Re: Turkey Point Plant Units 3 & 4  
Docket Nos. 50-250 & 50-251  
ECCS Analysis

Enclosed are answers to additional questions asked by your staff during the review of the Turkey Point ECCS analysis during the week of May 12, 1975.

MAY 16, 1975  
TURKEY POINT UNITS 3 & 4  
DOCKET 50-250 & 50-251

FIGURE 3

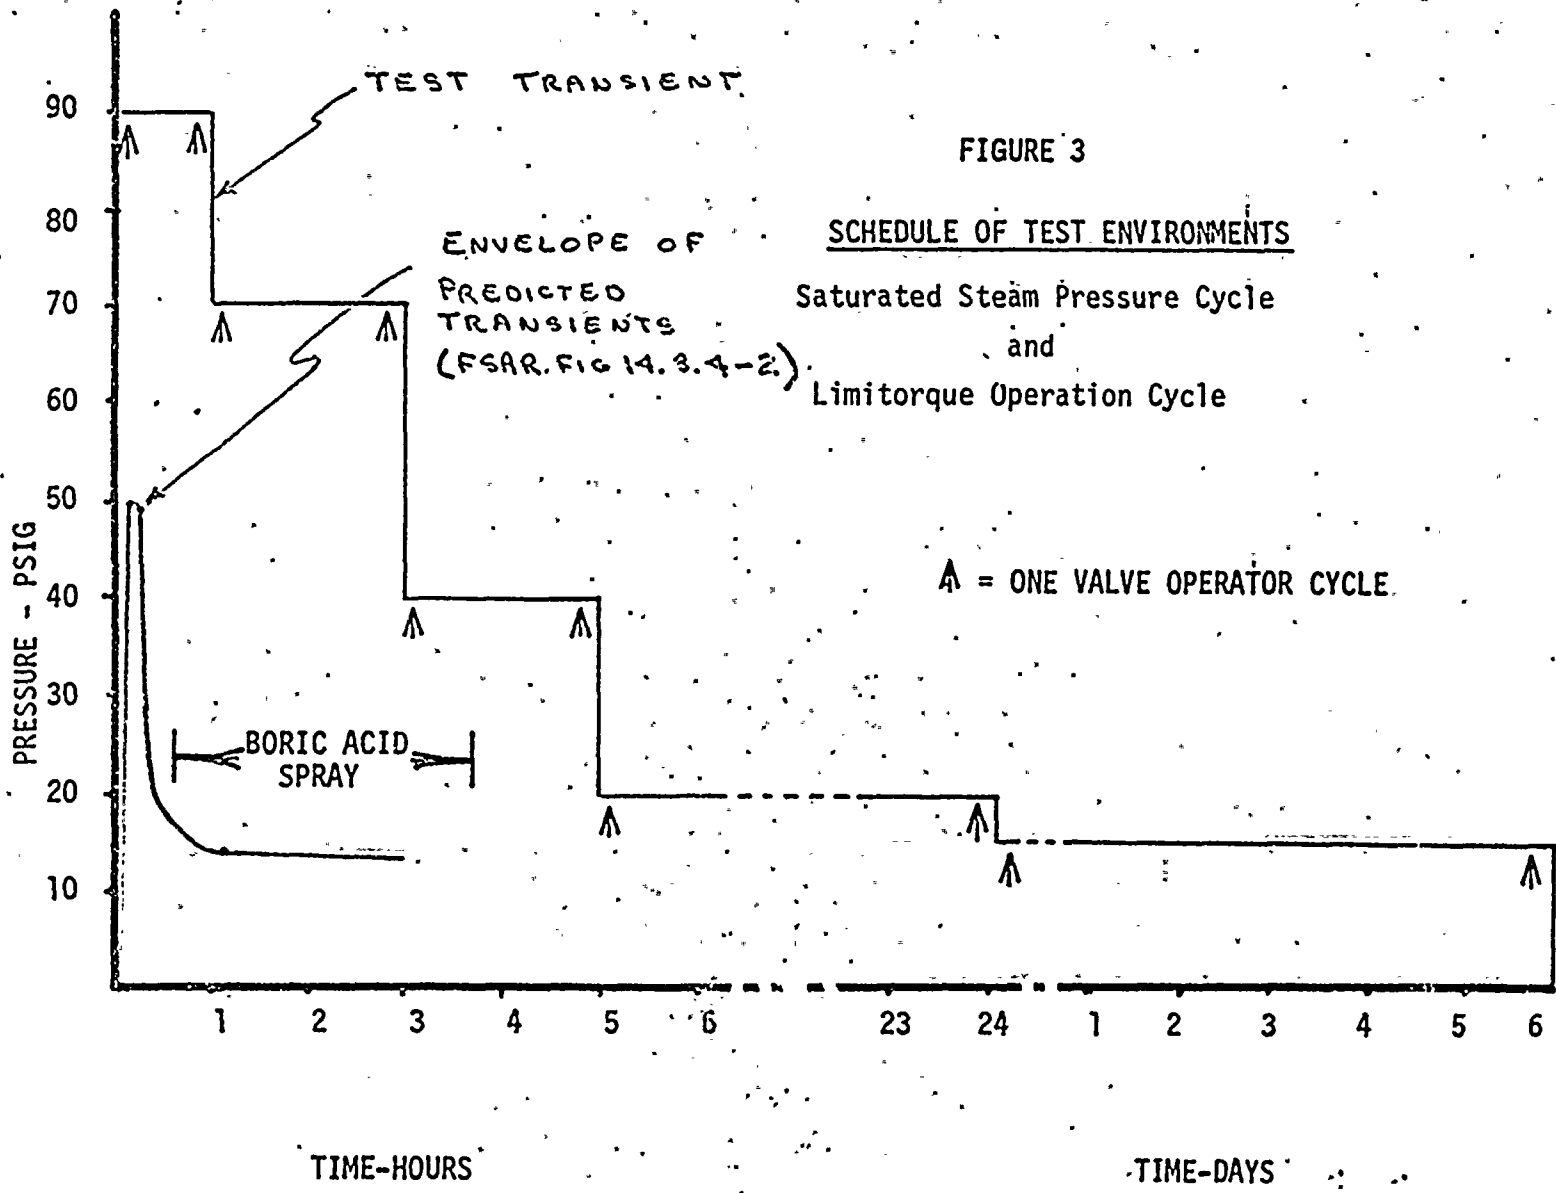
3. Q. What assurance do you have that motor operated valves 744A and B will operate in the post LOCA environment?

A. Motor operated valves 744A and B have operators which have been converted to class "H" operators which are specifically designed to operate after long term exposure to the post LOCA environment. A motor operator of similar design was subjected to severe environmental tests conducted under the direction of the valve operator manufacturer and the NSSS supplier. These tests were aimed at proving satisfactory operation over the long term.

The test subjected the valve to a pressure transient (using saturated steam) as shown in figure 3 which is attached.

The temperature transient corresponds to the saturated steam temperature at the given pressure. The conservatively calculated envelope of containment pressure transients following a LOCA are shown on figure 3 to demonstrate the conservatism in the test.
